**PUBLIC INTEREST REVIEW FOR GROUND WATER APPLICATIONS**

SUBJECT: Application G- 16828 Supersedes review of none  
Date of Review(s)

A. GENERAL INFORMATION: Applicant's Name: Melissa J. Ward & Louis P. Molt County: Harney

A1. Applicant(s) seek(s) (449 gpm) 1.00\* cfs from 1 well(s) in the Malheur Lake Basin,  
Silvies subbasin Quad Map: Poison Creek

Table showing water-level data for State Well HARN 463, State Observation Well # 167

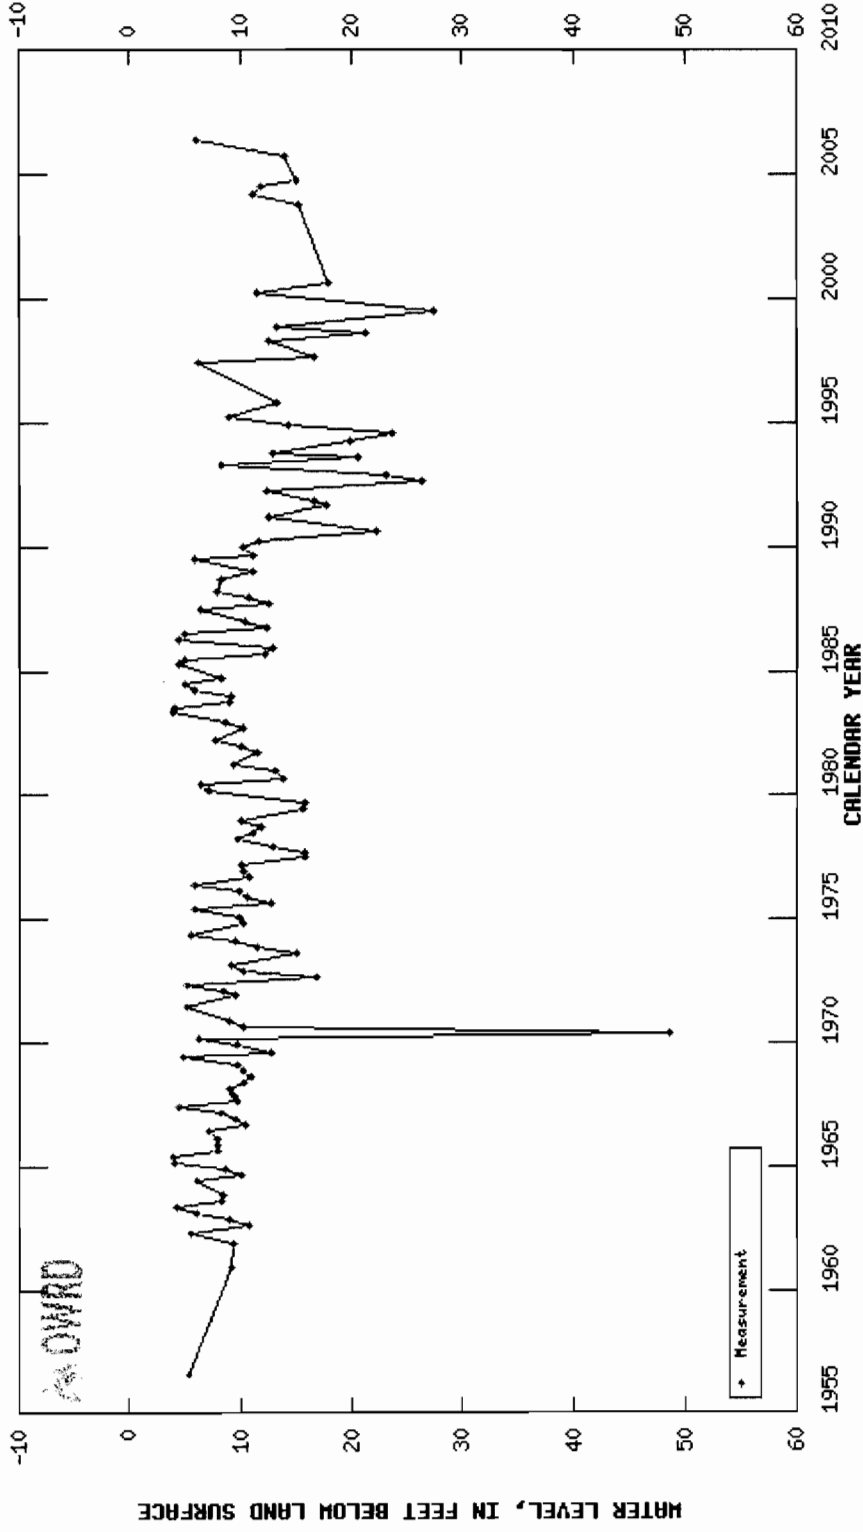
The closest wells with ground water level trend data are wells HARN 463 in T23S/R31E-sec 16 (about 3.5 miles to the south), and HARN 547 in T23S/R32E-sec 07 (about 4.6 miles to the southeast). Well HARN 463 appears to be in a recharge area, well HARN 547 does not. Both are in basin fill sediments downgradient of the applicant’s well. The ground water level data for both is from 1960 to 2006. The ground water level trend at each site show seasonal and climatic influences. A possible net decline of less than 5 feet may have occurred at HARN 547, but not at HARN 463. Interestingly, no recovery of the annual trend is apparent at HARN 547 from 1996 to 1999 (a generally wetter than average period in Oregon), but is apparent at HARN 463. Seasonal ground water level fluctuations range from 10 to 40 feet. This could adversely impact the use of shallow wells, but likely not adversely impact the use of deeper wells.

Proposed Well (G-16828) to Poison Creek & Slough

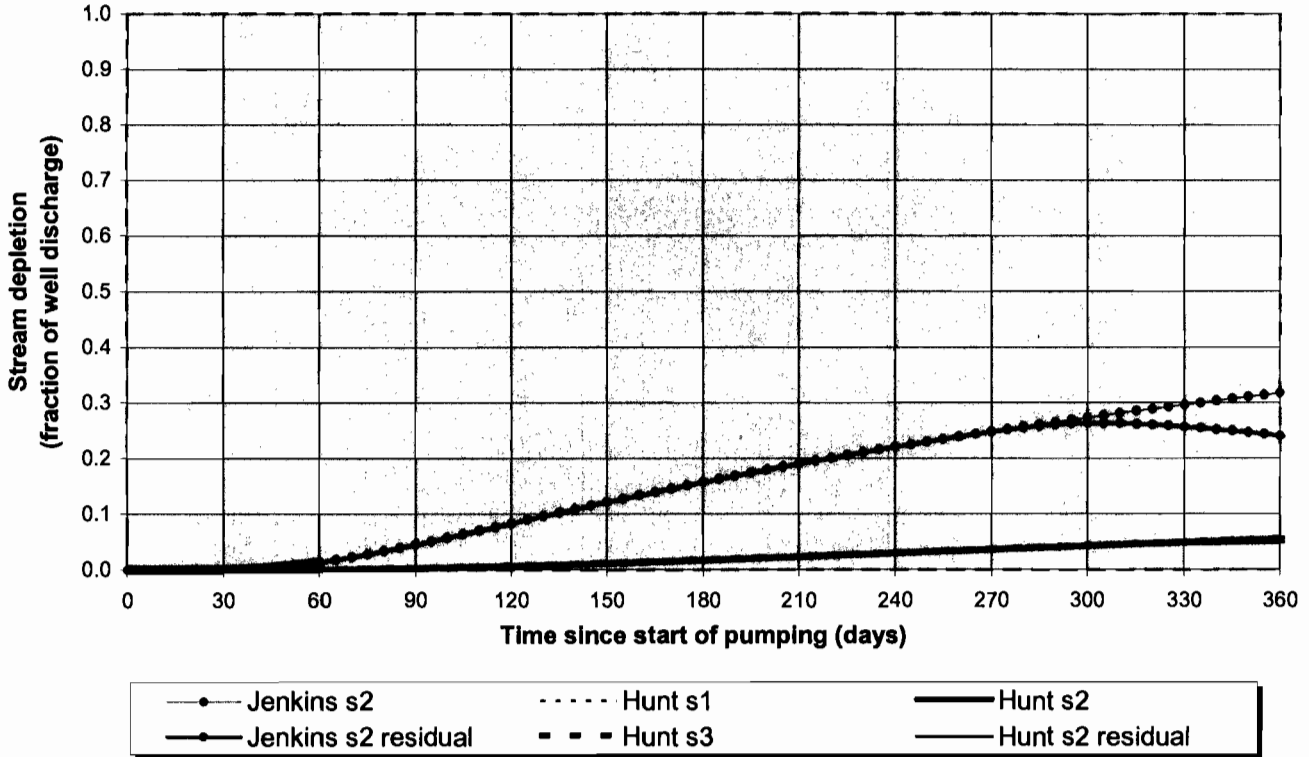
**The distance from the proposed well to the nearest reach of Poison Creek & Slough is less than 1 mile (3,250 feet). However in the vicinity of the proposed well and the nearest reach, surface water is perched above ground water. The ground water connection to surface water is not at the nearest reach, but about 14 miles southeast like Silvies River.**

**Hunt (1999) was used to calculate the interference at Poison Creek & Slough. The values used for the calculations are for the nearby basin fill sediments, the geologic material where the ground water connection to surface water occurs. The values used for the calculations are conservative and appropriate until better values become available. The calculations used a transmissivity of 7,500 ft<sup>2</sup>/day which is consistent for Eastern Oregon basin fill transmissivities noted by Gonthier (1985) and transmissivity values derived from specific capacity data from wells in T23S/R32.57E-sec 10, 13, 14, 15, 22, and 24 (HARN 564, HARN 641, HARN 642, HARN 645, HARN 648, HARN 649, HARN 650, HARN 651, HARN 657, HARN 1870, HARN 50054, HARN 50491, HARN 50514, and HARN 51204). The transmissivity derived from specific capacity data for the geologic material in the vicinity of the proposed well is similar. Additionally, the calculation used an assumed intermediate storage coefficient (0.001). The hydraulic conductivity assigned to the bed of the tributary is 0.20 feet/day.**
